SERVICE BULLETIN

Subject: DBA Phoenix-S Model C Float & Program Update Notification Date: 9/16/02

Distribution: All DBA Phoenix-S Model C Customers BulletinNo. CEB02-10

CUT OUT THE FOLLOWING GRAPHIC AND PLACE ON KEYPAD

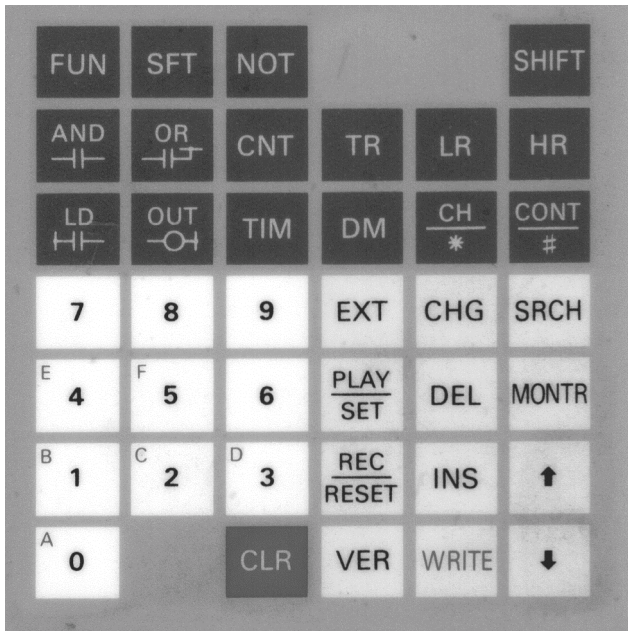
1. The float is threaded into the side of the tank with the arrow pointing toward the bottom of the tank. The float needs to be rotated 180-degrees clockwise until the arrow points towards the top of the tank.
2. Flip the dipswitches on the PLC so only the #3 switch is in the "ON" position. Make sure #1 and #6 are "OFF".
3. Turn the programming key in the keypad to PROGRAM and press CHANGE until the following appears:

4. Press these keys in the following sequence:
SET
RESET
5764
WRITE

5. Continue by pressing the following keys:
SHIFT
CONT
2
SEARCH

6. Continue to press SEARCH until the screen displays:

05515 CONT SRCH LD 00002	OR	05527 CONT SRCH LD 00002
-----------------------------	----	-----------------------------

LD
NOT
2
WRITE

05516READ AND HR0000	OR	05528READ AND HR0000
-------------------------	----	-------------------------
